RE: Independent Hydrogeological Review of  
Recent Data and Studies Related to California  
American Water's Proposed Monterey  
Regional Water Supply Project  
Weiss Job No. 466-2148

This draft report documents Weiss Associates (Weiss's) independent hydrogeological review of data and studies related to California American Water's (Cal-Am) proposed Monterey Regional Water Supply Project (MRWSP). The MRWSP is expected to extract predominately seawater pumped from a planned well field near the Monterey Bay shoreline in the City of Marina California.

Superposition Method Results for Model Layer 2 - Physical Inconsistencies - Example 1

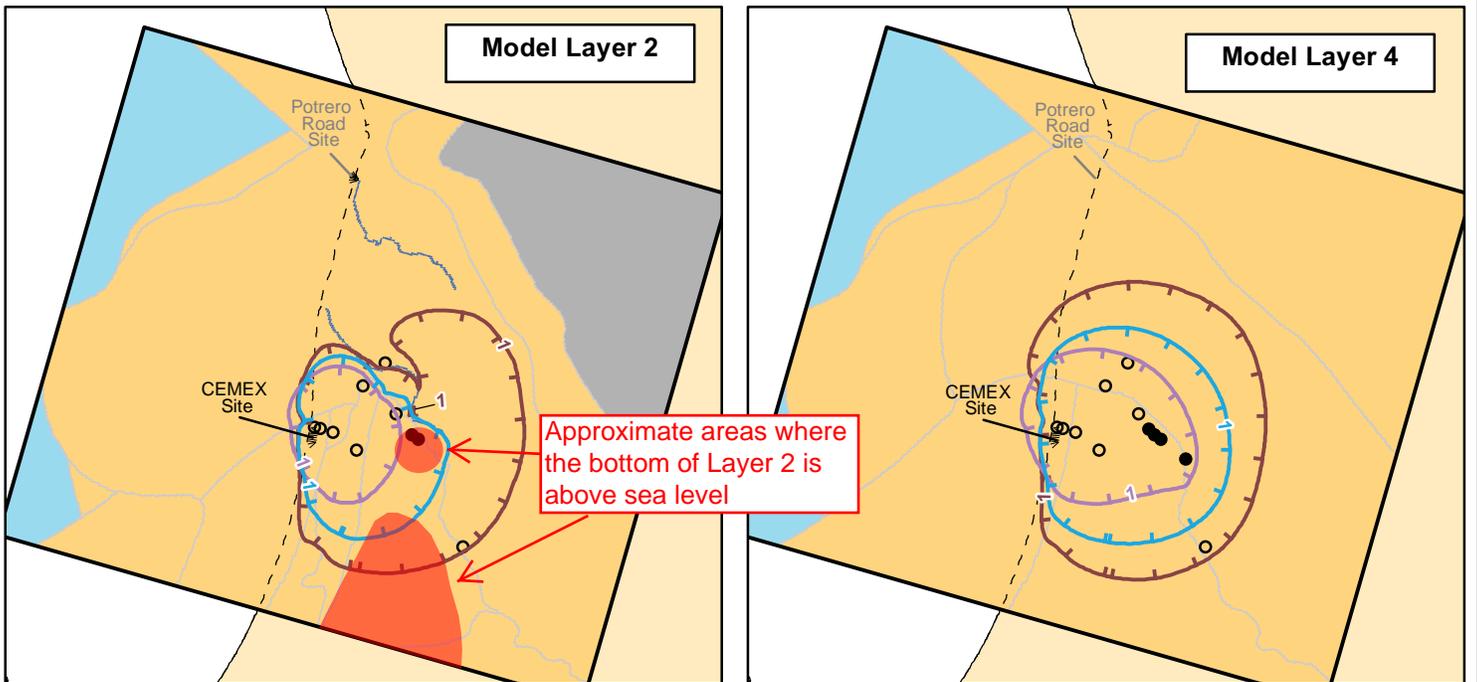
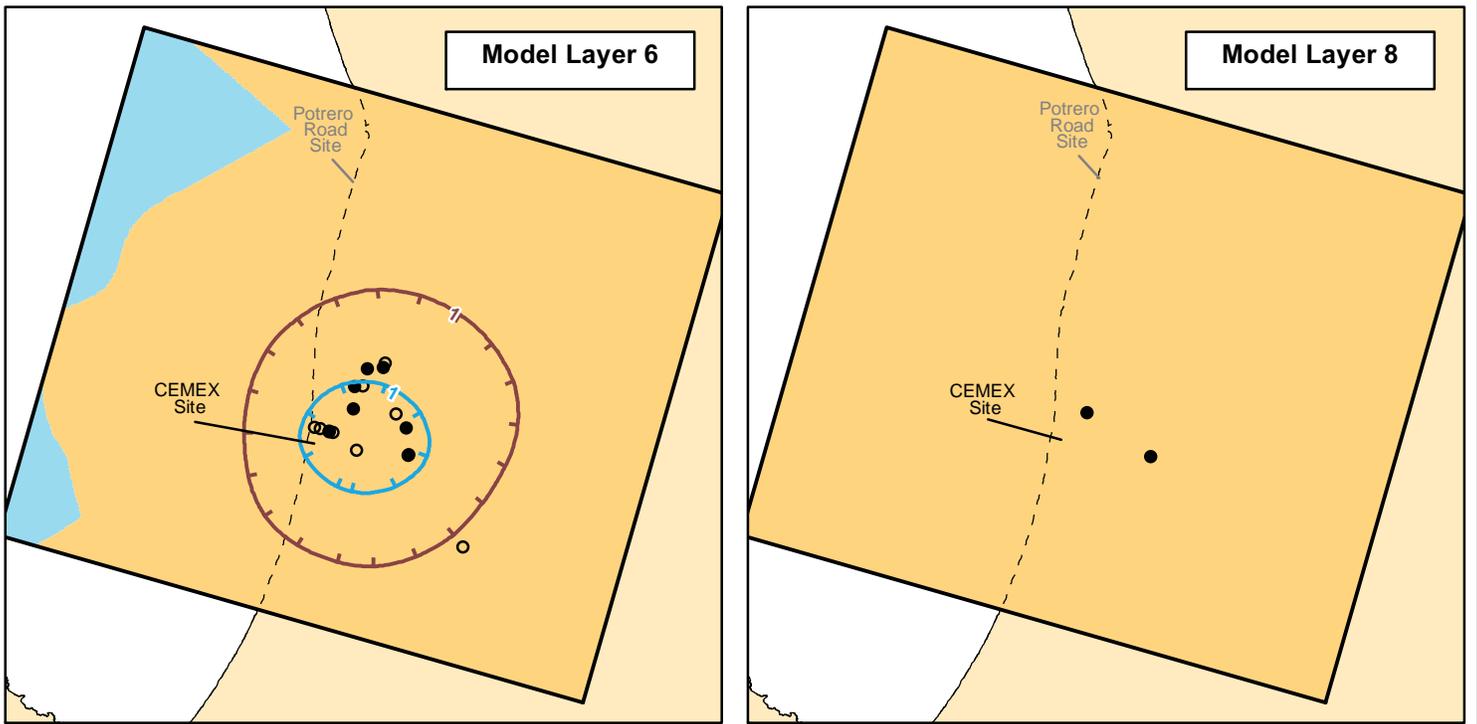
For these reasons, the accuracy of the Dune Sand Aquifer response to well field pumping modeled by the superposition application of NMGWM<sup>2016</sup> is questionable, and therefore superposition mode is not appropriate for calculating the expected effects of differences in the groundwater gradient on how the proposed project would affect the rate or volume of seawater intrusion into the aquifer or on how much fresh water the wells would extract. However, the NMGWM<sup>2016</sup> can be used in non-superposition mode to calculate these effects, as discussed below.

**Figure 36**

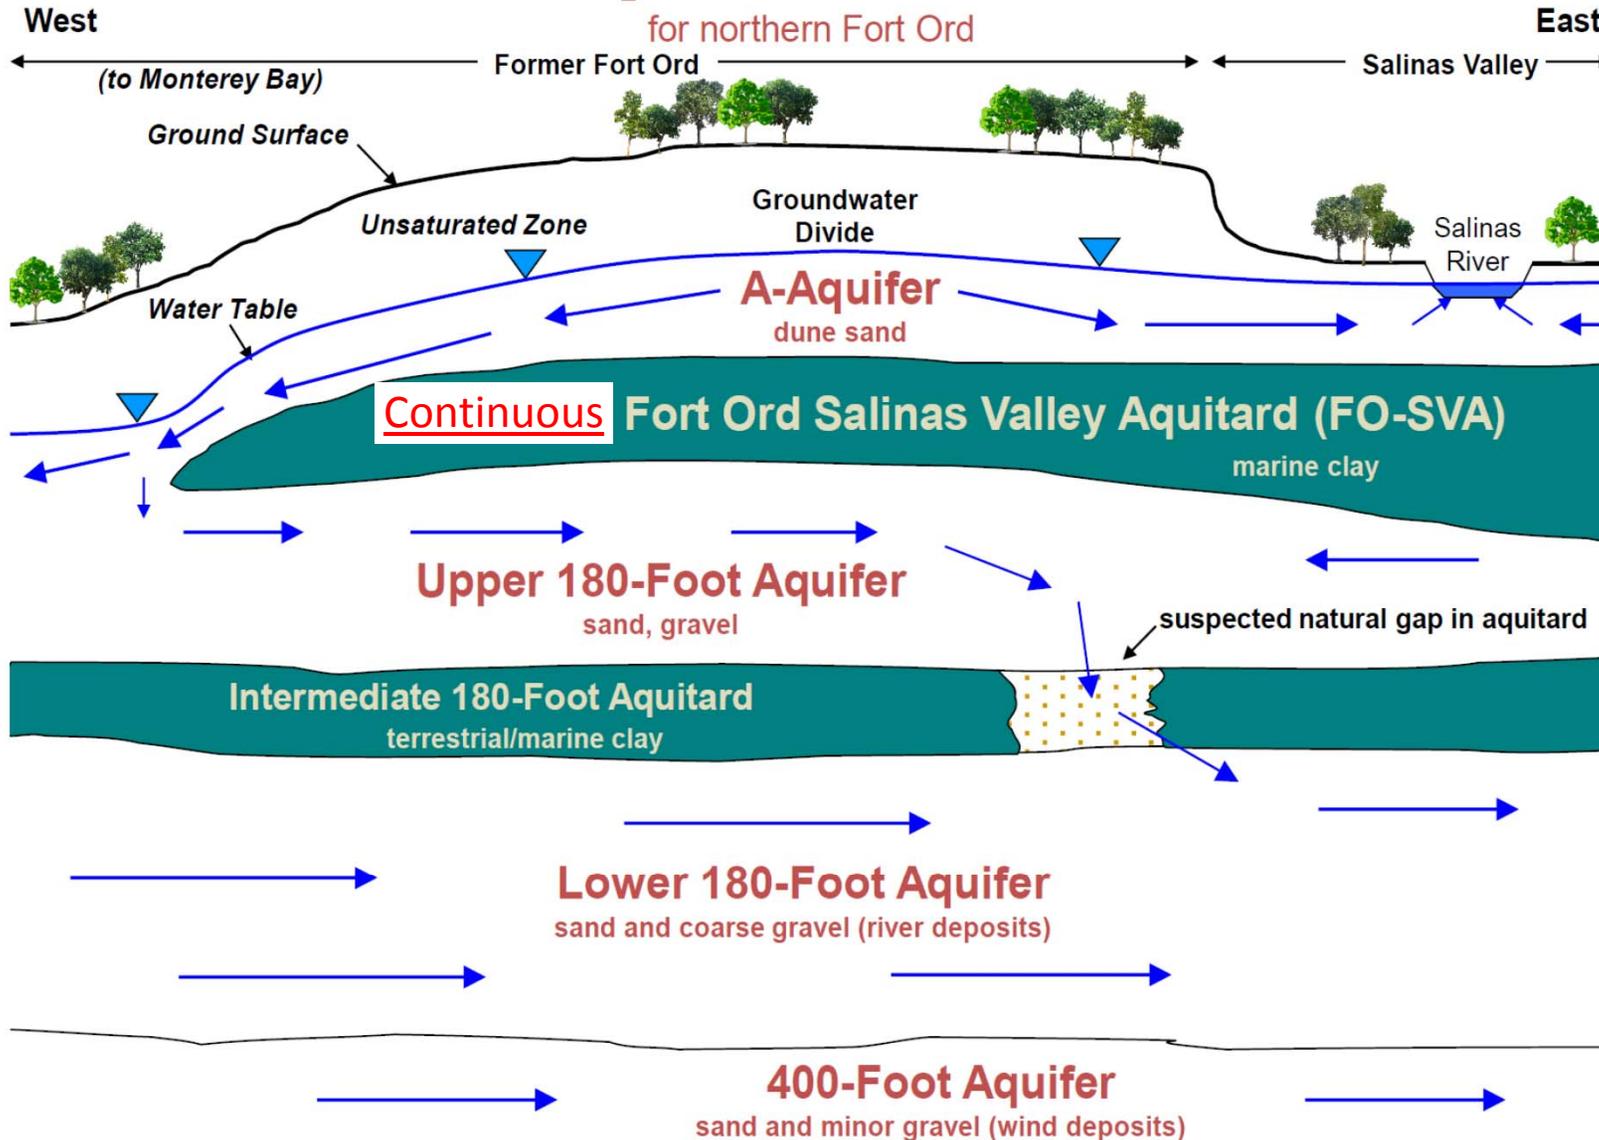
CSM-2 applies to the Fort Ord area, south of the MRWSP; whether or not it also applies to the area inland of MW-7 in the MRWSP project area is debated, as mentioned previously. CSM-2 assumes that the FO-SVA is continuous (Figure 36) and that recharge from rainfall enters the Dune Sand Aquifer and flows primarily horizontally above the FO-SVA. On the west seaward side, when this horizontal flow reaches the edges of the FO-SVA, it “waterfalls” downward to the underlying 180-Foot Aquifer, recharging it. And if pumping is occurring near the coast as is proposed at the MRWSP well field, a portion of this fresh water is more likely to be captured than if the fresh water is percolating down to the 180-Foot Aquifer further inland, as is the case with CSM-1.

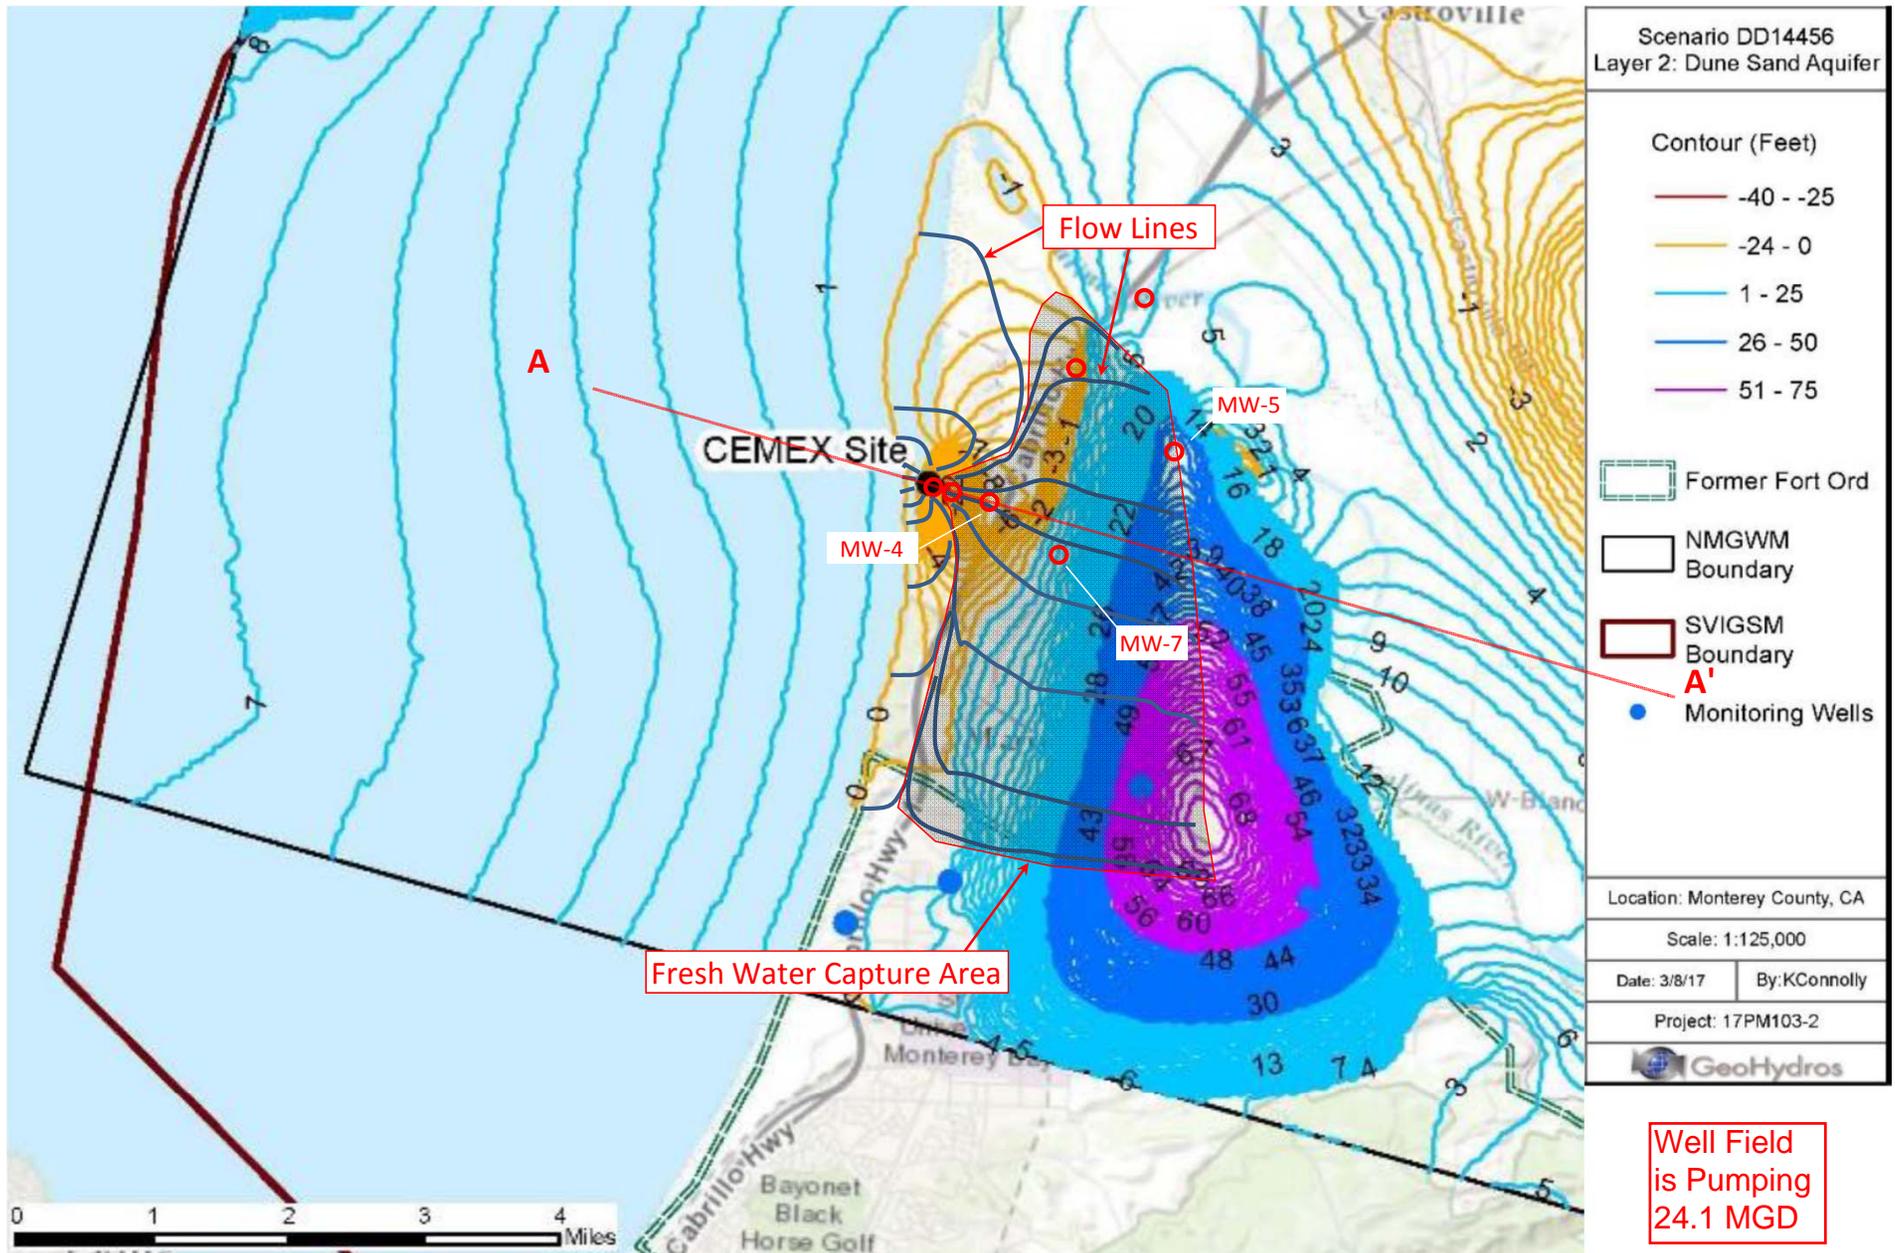
Additionally, Weiss performed a simplified flow net analysis using the contours generated to estimate the additional area over which fresh water would be captured by pumping (Figure 42) beyond the capture zones estimated for the Final EIR/EIS. This assumed area is approximately 7 square miles. Assuming annual average groundwater recharge of 5 inches per year (0.42 feet/year), as was done for the Final EIR/EIS OWP analytical estimates,<sup>(Appendix H of 7f)</sup> this results in a potential annual average capture volume of 1,900 acre-feet per year. Assuming a worst-case scenario where the well field was pumping at 15.5 MGD (equal to 17,360 acre-feet per year), and assuming an OWP from within the original capture zone of 96 percent from the Final EIR/EIS calculations, the additional captured volume equates to 1,900/17,330, or 11 percent. Subtracting this from the OWP of 96 percent provides an overall OWP of 85 percent.

However, this result is likely to be an underestimate of the true OWP, because it denies any flow of groundwater from the Dune Sand Aquifer to the 180-Foot Aquifer inland of the capture zone (approximately 2,000 to 4,000 feet inland of the pumping wells) defined by the Final EIR/EIS. The NMGVM<sup>2016</sup> (Figure 42) can also be used to generate a best-case scenario by estimating the horizontal flow towards the pumping wells through Layer 2, parameter Zone 20 (Figure 29). This layer has a hydraulic conductivity of 4 ft/day (Figure 27) in Zone 20. Given a conservatively high maximum seaward gradient of 0.0035, a length of Zone 20 of 4 miles perpendicular to the path of flow shown on Figure 42, porosity of 0.25, and a saturated thickness of 50 feet, the model can be estimated to produce a flow towards the pumping wells of only 30 acre-feet per year. This is because, as previously discussed, as modeled, most of the flow from Layer 2 is vertically downward to the 180-Foot Aquifer. This value is too small to have any effect on the original 96 to 99 percent estimated range in OWP calculated in the Final EIR/EIS and is likely to be unrealistically low.
